The paper „ Influence of the inflow conditions on the dynamics of a floating wind turbine wake under harmonic surge motion" by Barile et al. describes the outcomes of multiple Actuator Disk (AD) LES simulations of a floating wind turbine model under surge motion and different inflow conditions, including ABL. As there is currently a gap in the literature involving the understanding of FOWT's wakes under ABL conditions, the paper provides a valuable contribution to the wind energy community and the Wind Energy Science Journal. The overall quality of the results and manuscript is good; nevertheless, after reviewing the paper, I have some questions that should be addressed by the authors before the manuscript can be accepted for publication:

(b) Low-turbulence flow – $S_t = 0.32$ (c) ABL flow – $S_t = 0.32$

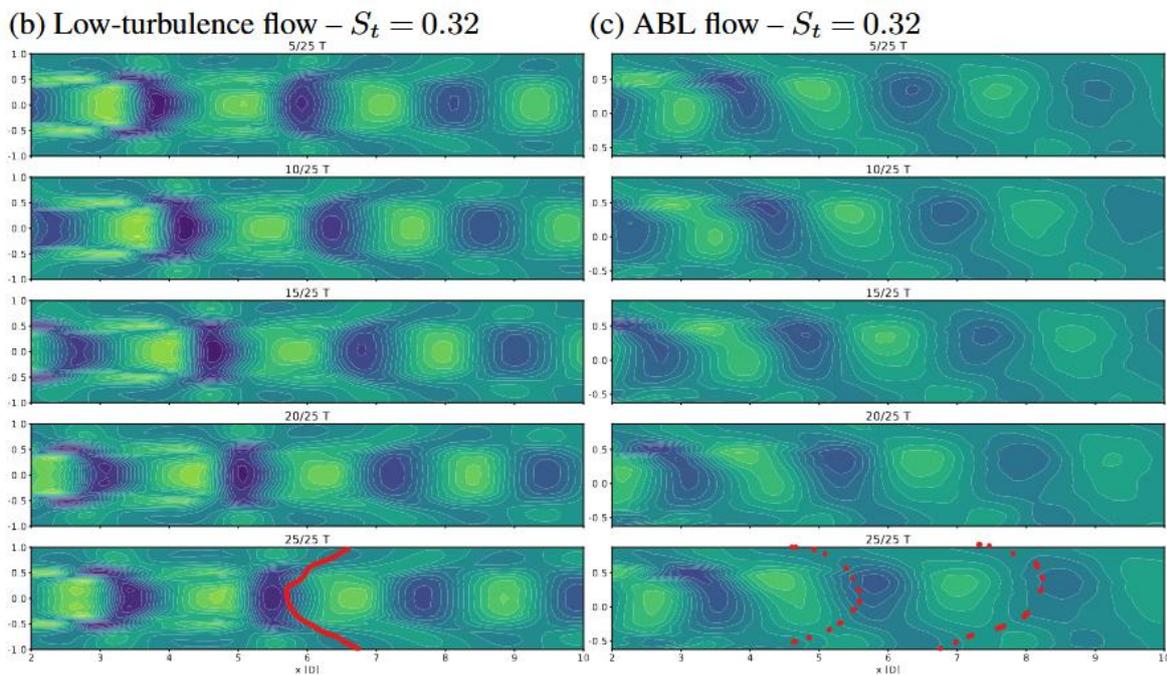
31) Figure 23, I wonder how this result combines with the ones in figure 21. In fact, there the authors described an inclination towards the left, while here the same conditions are seen as an inclination to the right (i.e., in the streamwise velocity). While I agree with the latter, I wonder if in Figure 21, we are actually observing an inclination to the left, or if the inclination is still towards the right, but the low-velocity zones are merging across different wake pulsations. In fact, in Figure 23, the shift of the wake pulsation in the bottom side of the wake is about 2D, matching the lines I have drawn in the Figure markup and the expected slower advection due to the ABL. Otherwise, If the authors do not agree with this explanation, how do they connect the different inclinations between Figure 23 and 21?
